UNITED STATES ENVIRONMENTAL PROTECTION AGENCY

TECHNICAL COMMENTS ON

DRAFT
REPORT TO
CHEROKEE COUNTY SITE
PARTICIPATING PRPsPILOT LEACH TESTING
GALENA SUBSITE, KANSASprepared by
Adrian Brown Consultants, Inc.
Dated: June 30, 1989

Figure 1
Partial Batch Test Results for Lead
(After/Before)

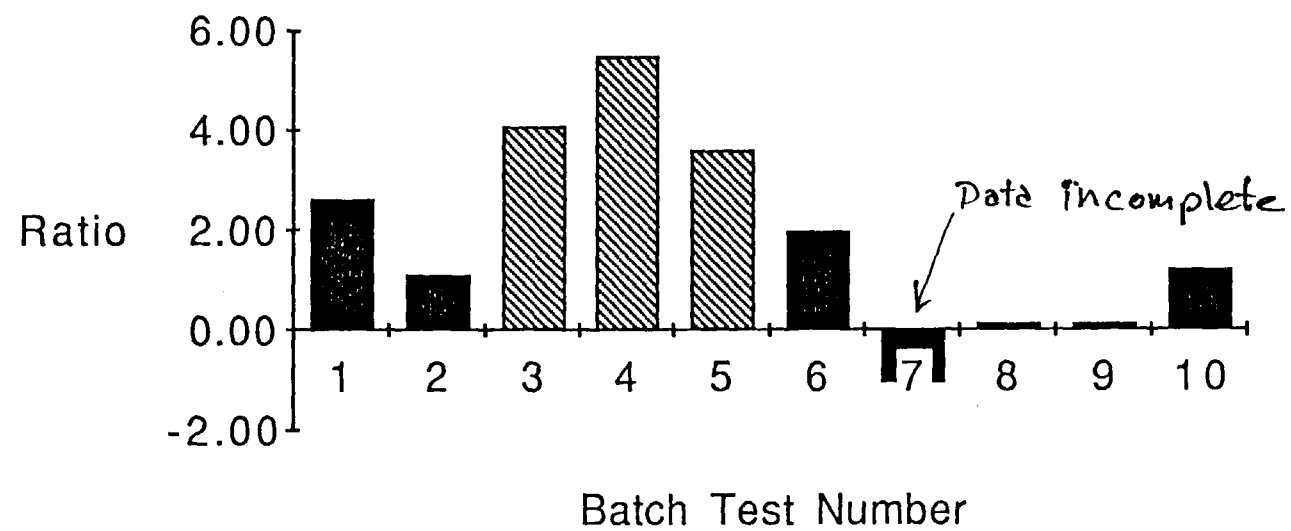
4. The batch test data are treated as a lump without looking at the individual tests. The attached graph (Figure 1) shows that the two unscreened and the single minus 2 inch batch tests leached more lead (Pb) than the other batch tests. These ratios are shown as tests 3, 4, and 5 on the figure (ratios are crosshatched to highlight them). Table 1 presents the ratio calculation bases for Figure 1.

The EPA disagrees with the basic conclusion of the ABC report that screening of the mine waste rock is unneeded for the selective backfill remedy. The batch test data show clearly excess lead leaching from the minus 2 inch materials and the unsorted materials (refer to Figure 1 attached).
